# Architectural Review Board

Wednesday, January 29, 2025

## 40 E. Bridge Street 24-142MPR

*East Elevation*

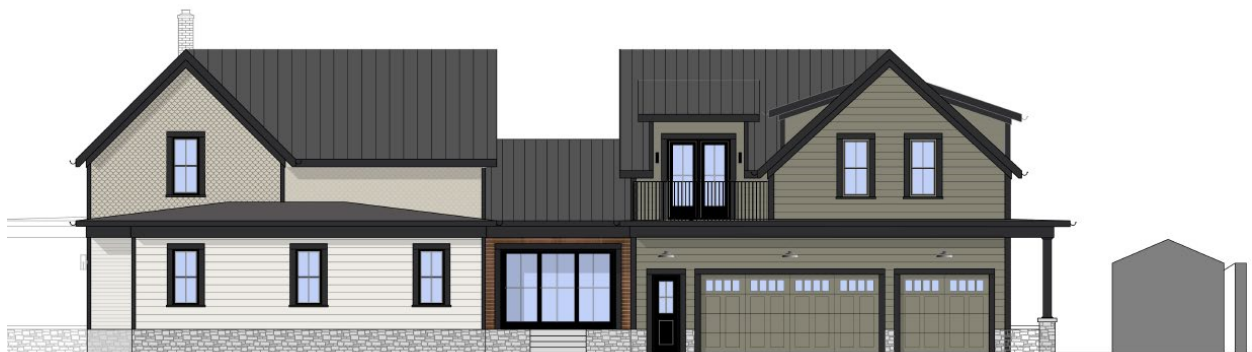
The east elevation is the new front façade of the house. A front porch addition is shown to accommodate the new front door, and square windows are added on the second story to provide upper story light. The applicant has shown appropriate organization of windows and doors per the Guidelines; the porch roof pitch mirrors the existing porch pitches at ¼:12 (see Waiver request herein), and an emphasized wide trim board detail mimics the original house.

The addition is clearly visible behind the historic house on the right side, as previously noted, although the form has been simplified since the last submittal. The square windows shown on the addition, along with those added to the original house, do not meet Code 153.174(D)(5), where windows shall have vertical proportions. Sills and lintels are required for all windows per Code 153.174(D)(4); the front façade’s square windows omit these. Discussion at the last Informal Review had some Board members supporting these square windows. Given the unique circumstances, staff supports the square windows in both locations. On the addition, they allow the shed dormer size to be minimized for better proportions. See Waivers herein.
